Re: NLH Capital Application (2018) – Labrador Interconnected Group RFIs LAB-NLH-035 to LAB-NLH-067

Requests for Information

by the Labrador Interconnected Group

1 **Requests for Information Regarding the Application for the Proposed Muskrat Falls to**
2 **Happy Valley-Goose Bay Interconnection Project (the “Application”)**

8 **Figure 6: Projected Rate Increase vs. Capital Investment**

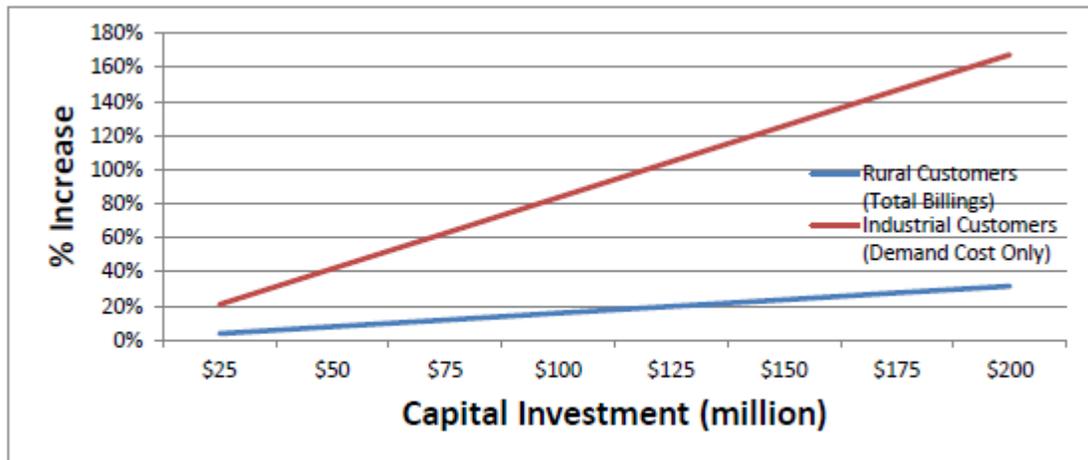
10 Figure 6 suggests a linear relationship between capital investment and rate increases.
11 However, given that the transmission expansion projects selected in the study are
12 large and “lumpy”, the relationship between load increases and rate impacts does not
13 follow a straight line.

14 Please present graphs, separately for Labrador East and Labrador West, that indicate:

- 15 a) On the x-axis, peak load,
- 16 b) On the left y-axis, capital expenditures for transmission infrastructure required to meet
17 the peak load on the x-axis, and
- 18 c) On the right y-axis, the % rate increase for rural and industrial customers resulting from
19 those investments.
